UNITED STATES  
DEPARTMENT OF THE INTERIOR  
BUREAU OF LAND MANAGEMENTFORM APPROVED  
OMB NO. 1004-0135  
Expires: July 31, 2010**SUNDRY NOTICES AND REPORTS ON WELLS**  
*Do not use this form for proposals to drill or to re-enter an abandoned well. Use form 3160-3 (APD) for such proposals.*5. Lease Serial No.  
NMNM043625

☒ Oil Well ☐ Gas Well ☐ Other8. Well Name and No.  
SAGUARO AGS FEDERAL 3

Yates Petroleum Corporation plans to plug and abandon this well as follows:

**WELL NAME:** Saguaro AGS Federal # 3      **FIELD:** Dagger Draw  
**LOCATION:** 1,980' FNL & 1,980' FWL of Section 26-20S-24E      Eddy Co., NM  
**GL:** 3,655'      **ZERO:** 15'      **KB:** 3,670'  
**SPUD DATE:** 3/11/71      **COMPLETION DATE:** 5/23/71  
**COMMENTS:** API No.: 30-015-20396

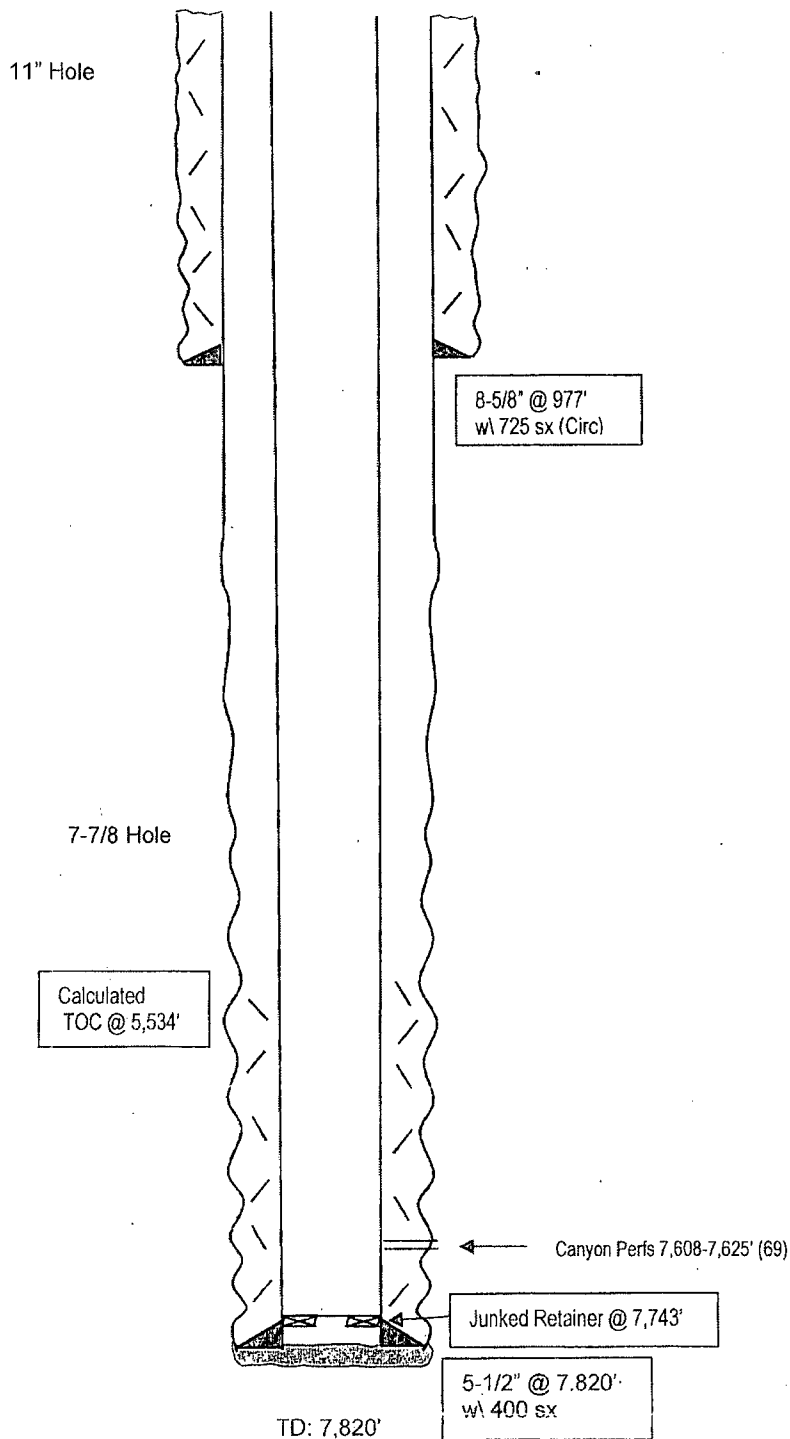
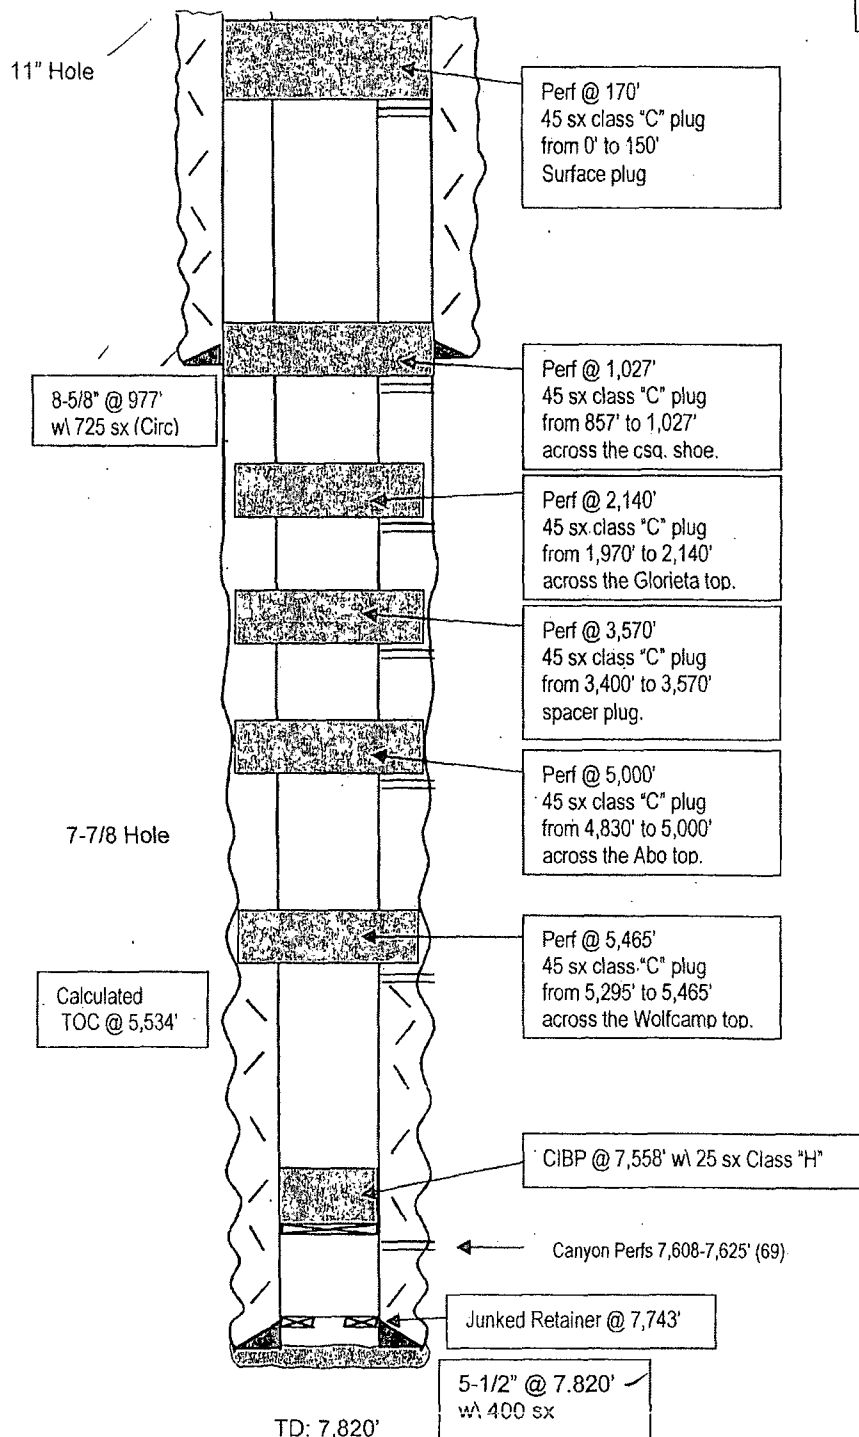
1. NU BOP. RU all safety equipment as needed. No casing recovery will be attempted as production casing is cemented to surface. *Not cemented to surface.*
2. Set a 7 inch CIBP at 7558 ft and cap it with 25 sx Class H cement.
3. Engineer Calc TOC 5534 ft, no logs or records of a CBL could be found, so from here on out we are going to perf at each plug to ensure that cement is present behind the casing (well originally drilled by Conoco).
4. Perf 4 shots at 5465 ft. Pressure up on casing to 500 psi. If we can pump into perfs spot a 45 sx Class C cement plug inside and outside casing from 5295 ft - 5465 ft. If the casing holds pressure, spot a 170 ft plug inside the casing from 5295 ft - 5465 ft. WOC and tag; reset if necessary. This will place a plug across Wolfcamp top.
5. Perf 4 shots at 5000 ft. Pressure up on the casing to 500 psi. If we can pump into perfs spot

**RECLAMATION PROCEDURE  
ATTACHED****SEE ATTACHED FOR  
CONDITIONS OF APPROVAL***Accepted for record  
5/2/15*
